TECHNICAL SERVICE BULLETIN

Product: Cornelius Viper 60Hz

Subject: Condenser Fan PN replacement 620073140 – 2nd revision

Date: 6/29/2022

Damaged Fan Blade

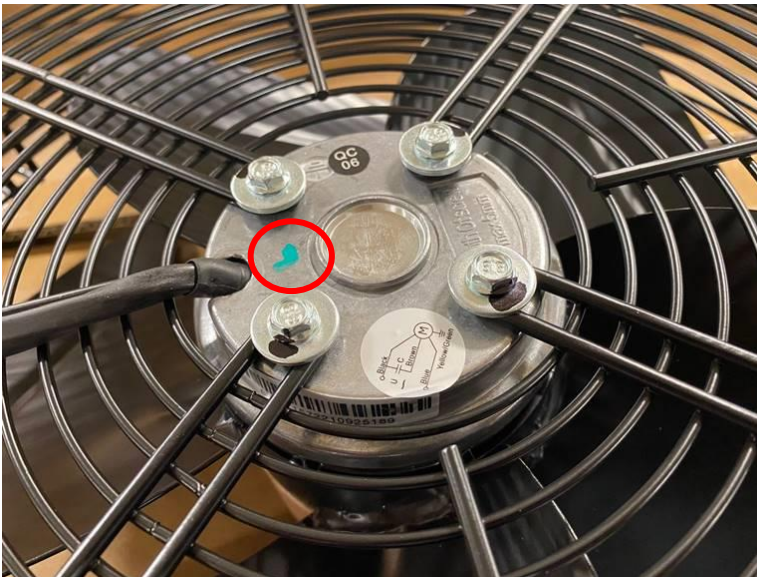
On a small percentage of 60Hz Viper units, there is potential for the fan blade to develop a fracture or crack near the fan blade hub. While this condition does not create a safety risk; if left unrepaired it could require additional repairs to the condenser or other components.

Improper attachment of fan blades to condenser fan motor

The issue will usually be accompanied by excessive / metallic fan noise, visible vibration of the fan cage, or system errors as noted below:

- System high head pressure, intermittent or damaged compressor, high barrel temperature
- The issue should be immediately addressed when identified to avoid unit damage

If identified, immediately shut down the unit to avoid further damage.

- Replace the damaged fan, using replacement fan PN: 620073140. Identification for new fan is a presence of green paint mark as depicted below:

- If the condenser is damaged, replacement of the condenser is also required.
